Estill County, Ky Rt 89

Value Engineering - Study Identification

Project: FD04-033-0089-012-015 0250 Team: #1
 Location: ESTILL COUNTY, KY 89 Date: 4-27-99

PROJECT: KY 89 Relocation

2 - LANE RURAL NORMAL CUT/FILL SECTION

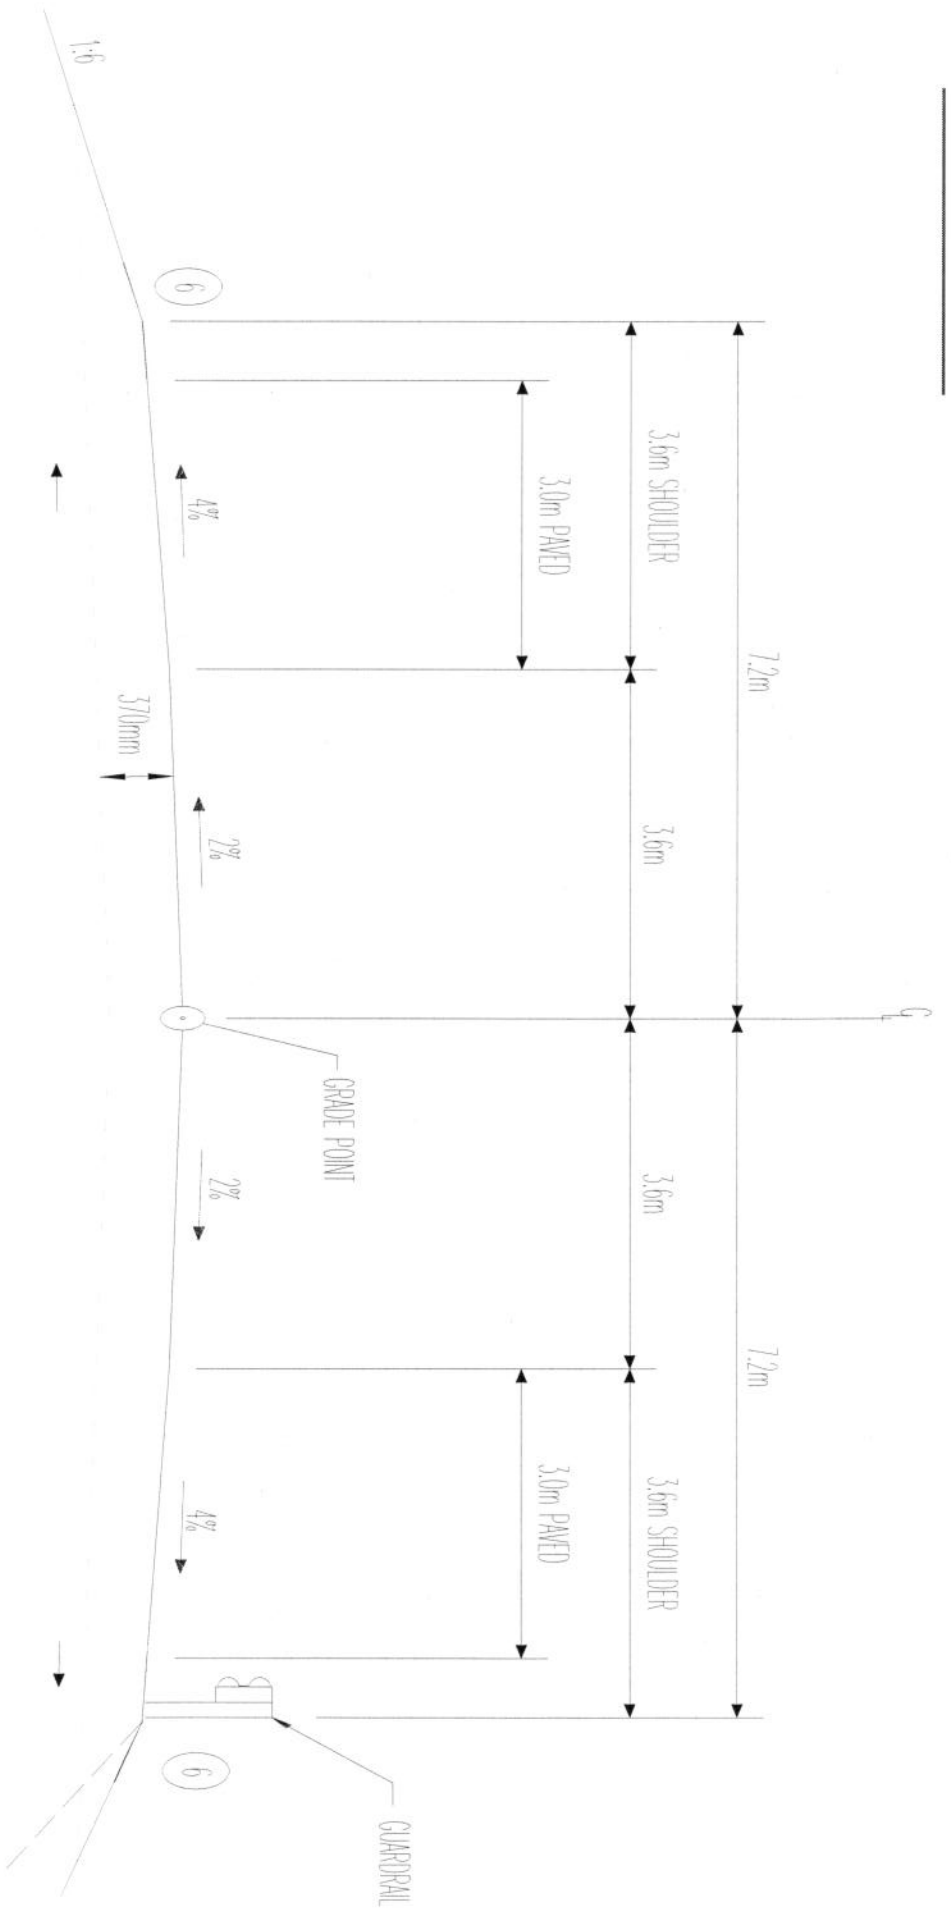
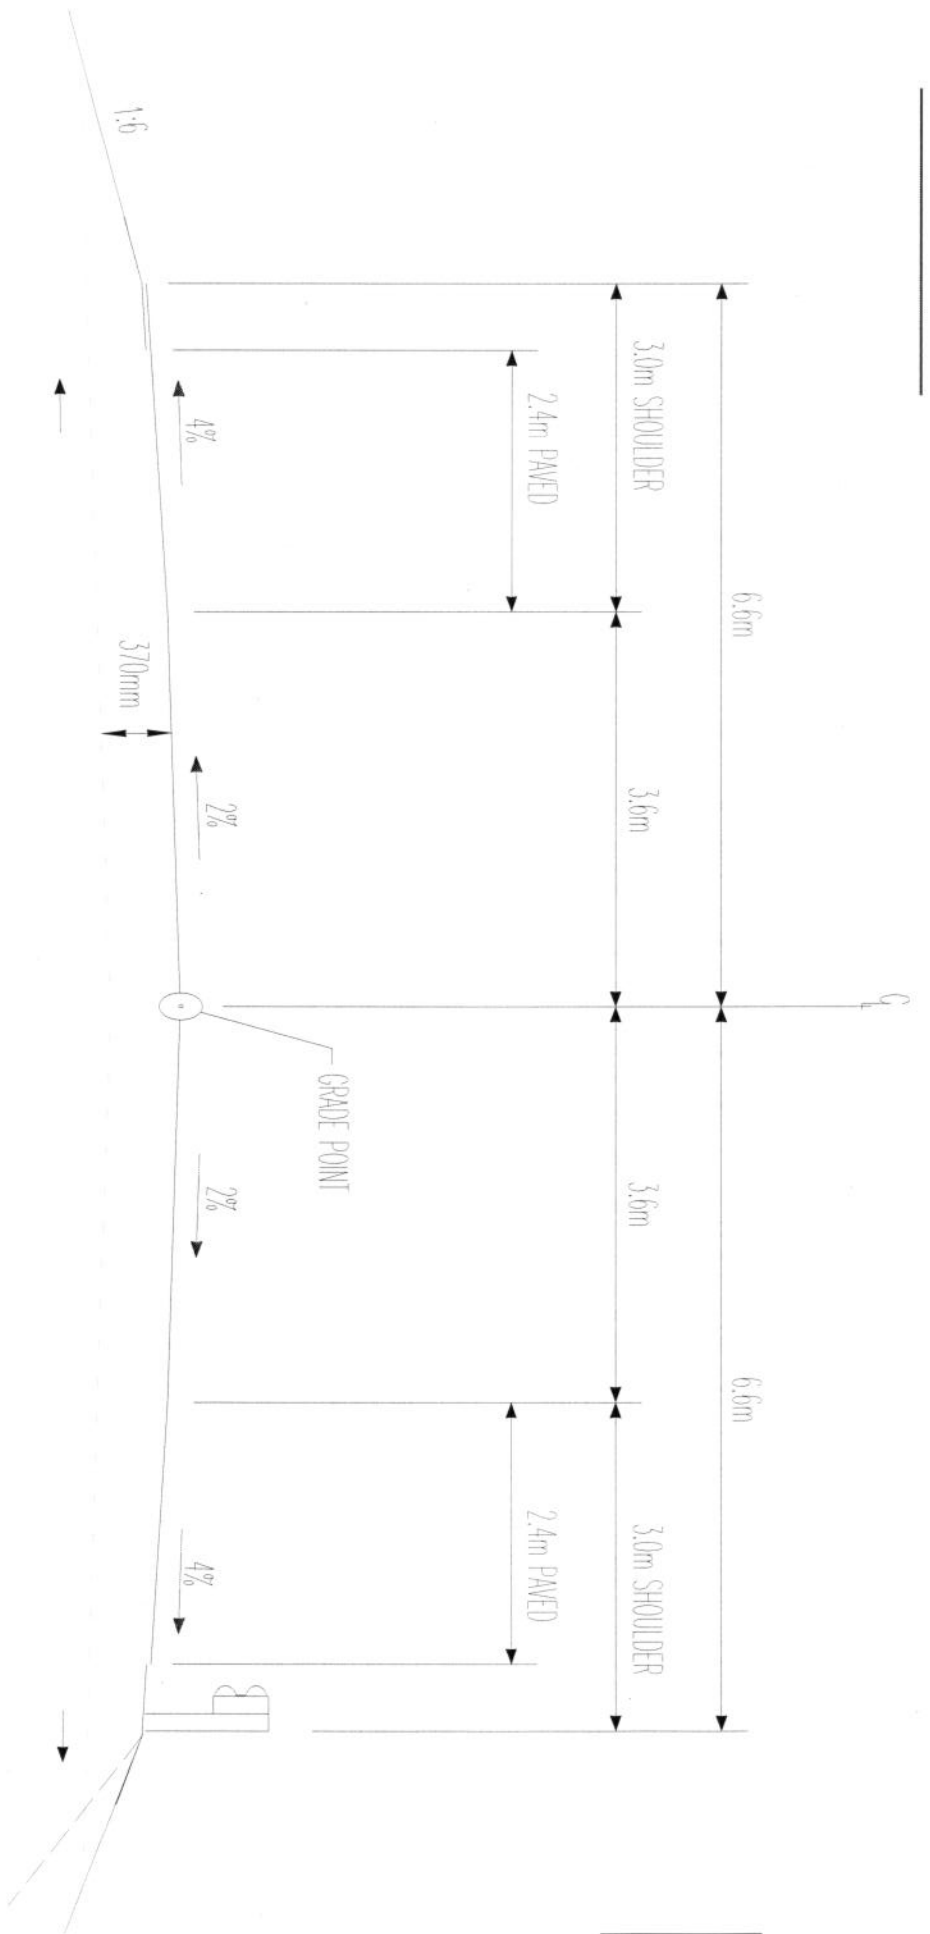
DESCRIPTIVE TITLE OF RECOMMENDATION: Change width of paved shoulder on north end of project

The original design called for a 3.6 m shoulder with a 3.0 m paved shoulder.

The recommended change is to construct a 3.0 m shoulder with a 2.4 m paved shoulder.

The advantage of reducing the width of the paved shoulder from 3.0m to 2.4m is a cost savings in two areas. The first savings will be in the reduction of asphalt and OGA used in the construction of the shoulder. The second savings will be from a reduction in roadway excavation due to the smaller width of the roadbed.

The disadvantage of reducing the shoulder is a safety concern. A wider shoulder will allow more room for vehicles in trouble and add to the comfort of the motoring public. The smaller shoulder will also be more difficult to construct.

The justification for using a smaller shoulder is based on the cost estimate and the safety factor. Using a reduced shoulder will result in over \$121,000 of savings. Also the Kentucky Highway Design Manual calls for a 2.4m shoulder for a road of this type. Therefore, the proposed alternative has a lower cost and a shoulder considered to be safe according to Kentucky design practices.

● 2-Lane rural original

● 2 Lane Rural Proposed Alternative

TYPICAL BRIDGE SECTION
 BRIDGE OVER WHITE OAK CREEK

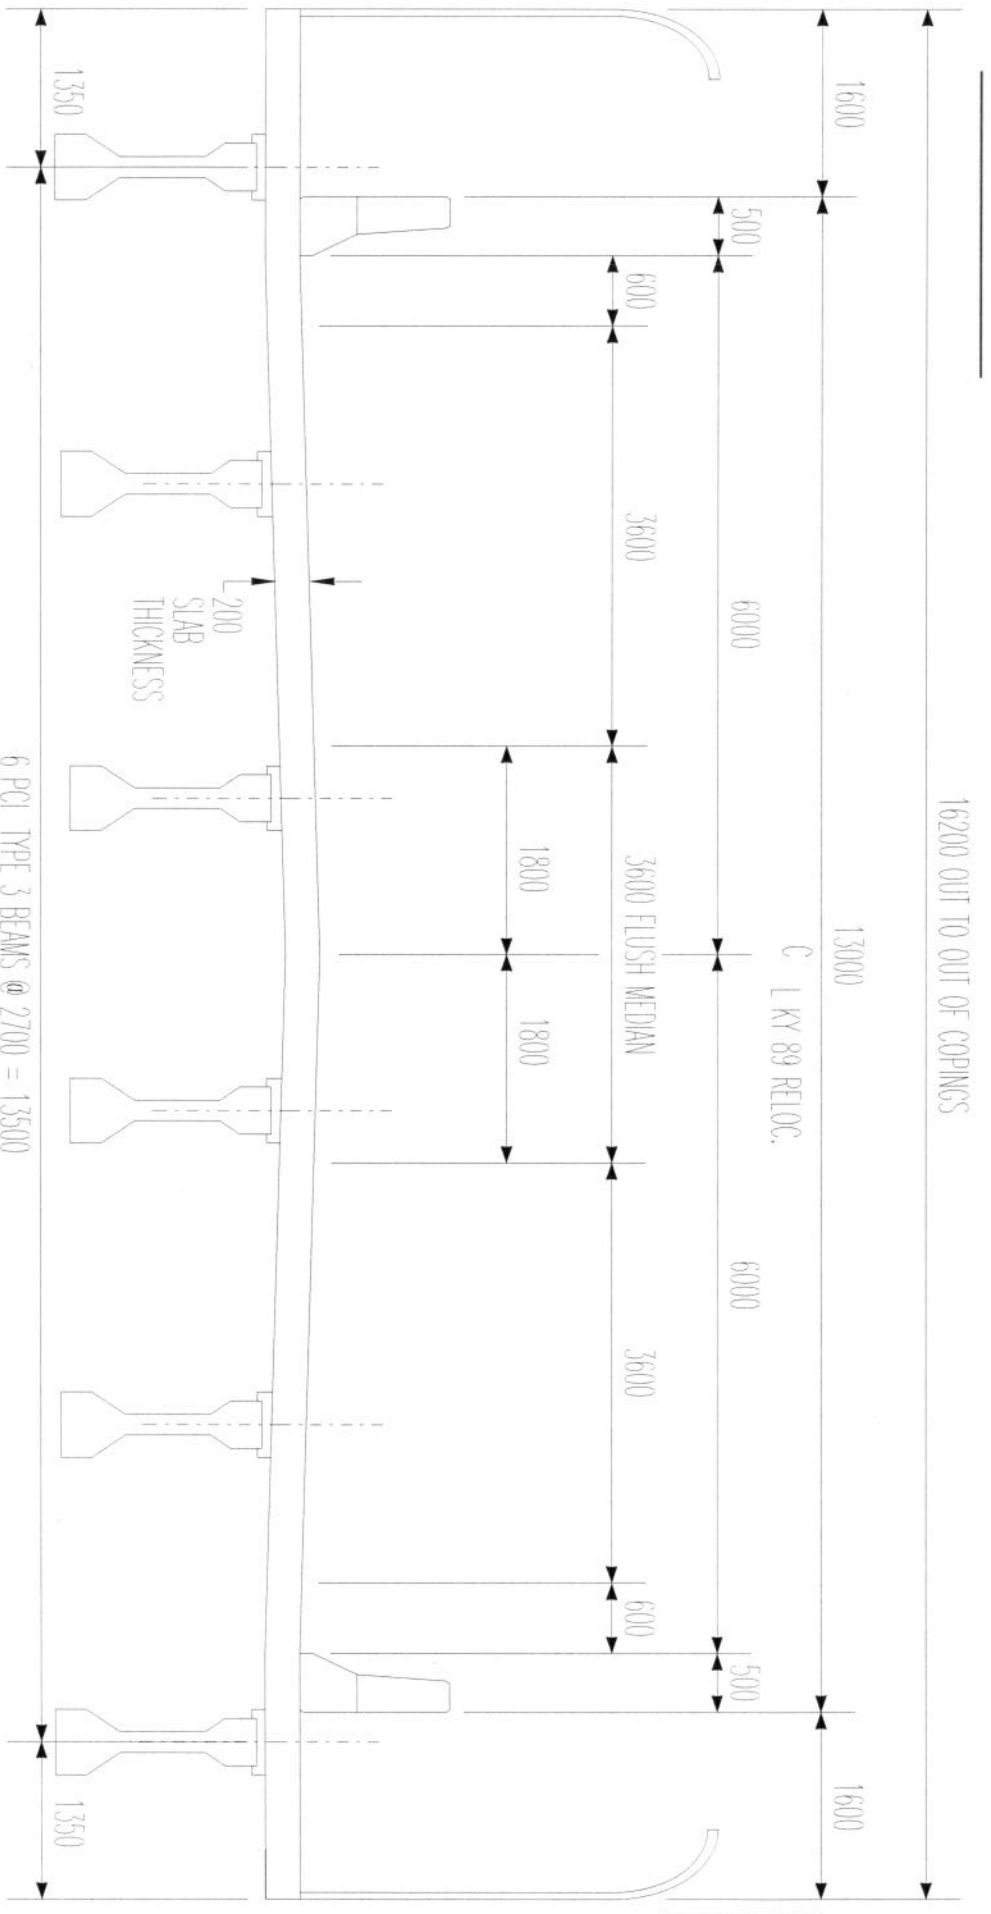
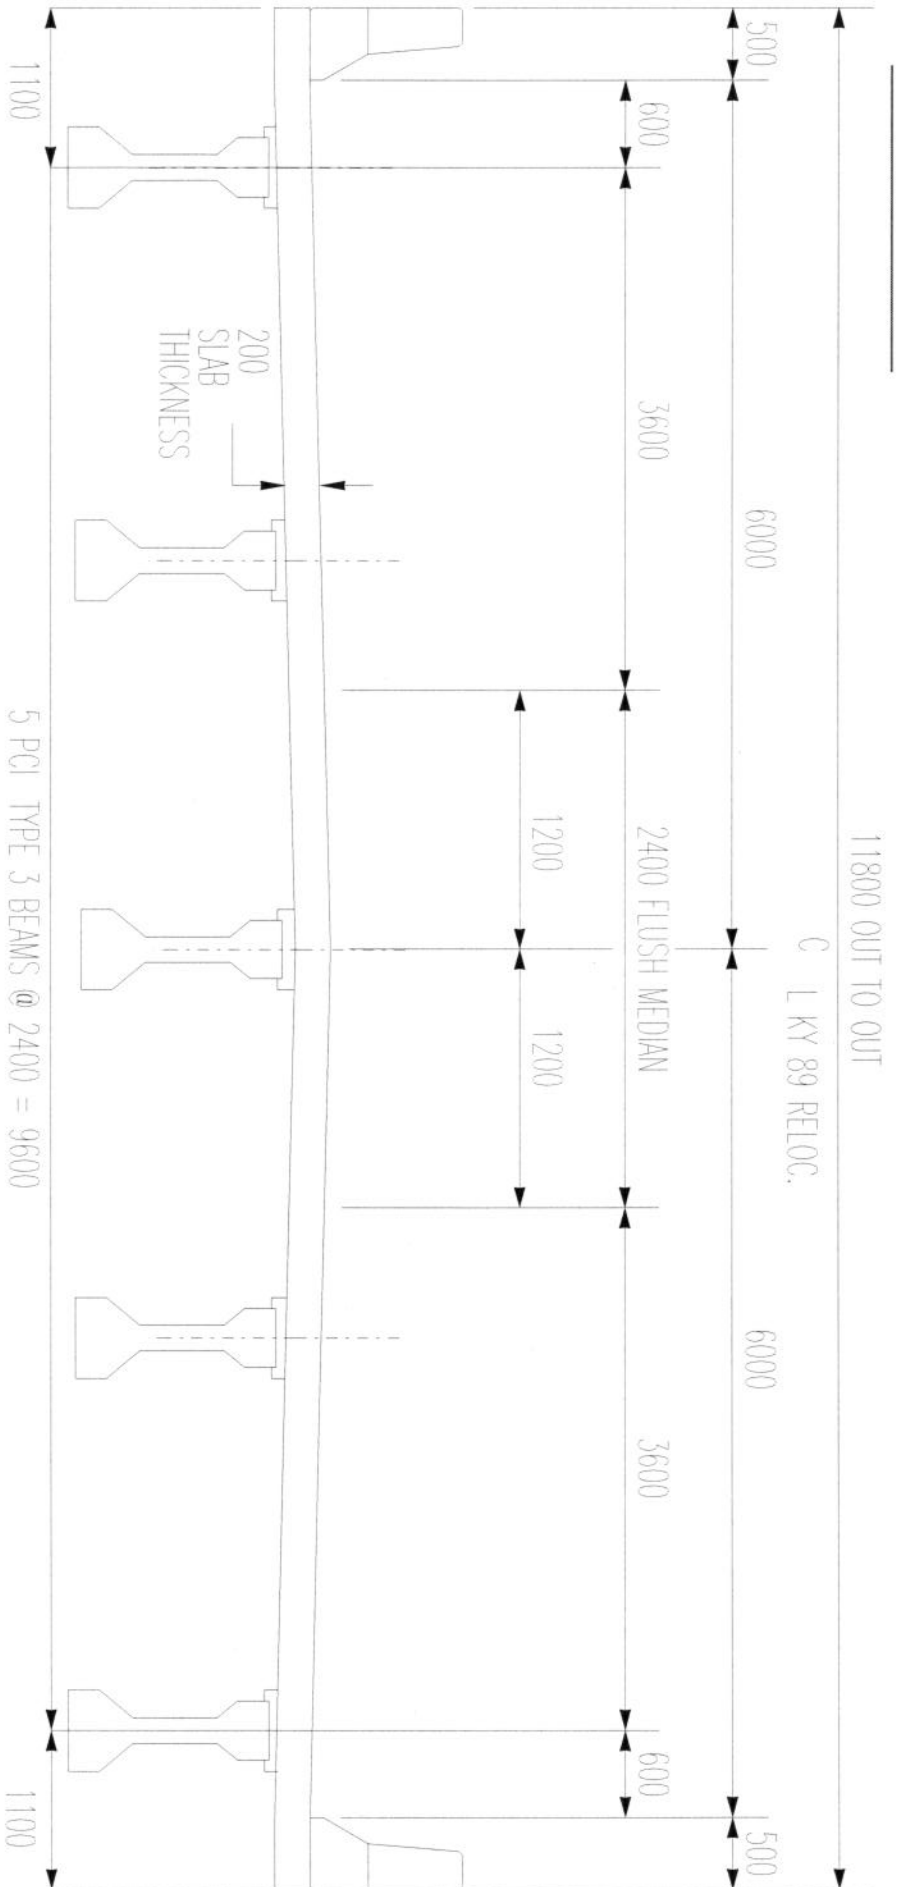
DESCRIPTIVE TITLE OF RECOMMENDATION: MODIFY BRIDGE @ WHITE OAK CREEK

ORIGINAL DESIGN: THE ORIGINAL BRIDGE DESIGN WAS 12m - 20m - 12m 3 SPAN BRIDGE WITH TYPE 3 P.C.I. BEAMS. THE ORIGINAL WIDTH OF THE BRIDGE WAS 16.2 METERS, THIS INCLUDED A 1.6 METER SIDE WALK ON SIDE OF THE BRIDGE AND A 3.6 METER FLUSH MEDIAN.

RECOMMENDED CHANGE: THE RECOMMENDED CHANGE TO THE ORIGINAL DESIGN IS TO SHORTEN THE WIDTH OF THE 3 SPAN BRIDGE, WE PROPOSE TO DELETE THE 1.6 METER SIDEWALKS ON EACH SIDE OF THE BRIDGE. ALSO, WE PROPOSE TO REDUCE THE WIDTH OF THE FLUSH MEDIAN FROM 3.6 METERS TO 2.4 METERS. THE TOTAL REDUCTION IN WIDTH OF THE BRIDGE IS 4.4 METERS.

ORIGINAL DESIGN RECOMMENDED 3-SPAN BRIDGE (12m-20m-12m) TYPE III PCI B OVER WHITE OAK CREEK TO REPLACE EXISTING 9000 mm X 3000 mm CONCRETE ARCH. ORIGINAL DESIGN TYPICAL RECOMMENDED 3600 mm FLUSH MEDIAN, (2) 3600 mm, (2) 600 mm SHOULDER, (2) BARRIER WALLS (500 mm) AND 1600 mm SIDEWALKS ON EACH SIDE OF BRIDGE. TOTAL OUT-TO-OUT 16200 mm.

V.E. RECOMMENDATION IS TO ELIMINATE SIDEWALKS, REDUCE FLUSH MEDIANS TO (2) 1200 mm TOTAL 2400 mm & ELIMINATE CURBS. TOTAL REDUCTION OF DECK WIDTH OF 4.4 METERS. REDUCTION IN DECK WIDTH WILL ELIMINATE 44 L.M. OF TYPE III PCI BEAMS. THIS REDUCTION IN DECK AREA WILL ALSO ALLOW SAVINGS IN THE SUBSTRUCTURE TOTAL OUT-TO-OUT FOR V.E. RECOMMENDATION IS 11800 mm.
DECK REDUCTION OF $4.4 \text{ m} \times 44 \text{ m} = 193.60 \text{ m}^2$

ADVANTAGES: BY REDUCING THE WIDTH OF THE BRIDGE OVER WHITE OAK CREEK, WE CAN DIMINISH THE CONFUSION OF PEDESTRIANS. THERE ARE SIDEWALKS LEADING UP TO THE BRIDGE, BUT THERE ARE NOT SIDEWALK BEYOND THE BRIDGE. THEREFORE, WHY CONTINUE THE SIDEWALKS ONTO THE BRIDGE WHEN THEY WILL JUST END WHEN THE BRIDGE ENDS. ALSO, THERE IS A SIGNIFICANT COST SAVINGS THAT COMES ALONG WITH THE WIDTH REDUCTION OF THE BRIDGE.

DISADVANTAGES: THERE WILL BE LESS AREA FOR THOSE PEDESTRIANS THAT MIGHT CHOOSE TO WALK ACROSS THE BRIDGE. THERE WILL BE SOME REDUCTION IN SAFETY BECAUSE THERE WILL NOT BE A BARRIER WALL BETWEEN THE TRAFFIC AND PEDESTRIANS.

JUSTIFICATION: THE SIDEWALK ELIMINATION STILL ALLOWS FOR ADEQUATE PEDESTRIAN TRAFFIC FLOW & SAFETY, WHILE SAVING \$121,000. ALSO, THE REDUCTION IN MEDIAN WIDTH DOES NOT COMPROMISE SAFETY, BUT SAVED A SIGNIFICANT AMOUNT OF FUNDS.

Original Bridge

Preferred Alternative Bridge
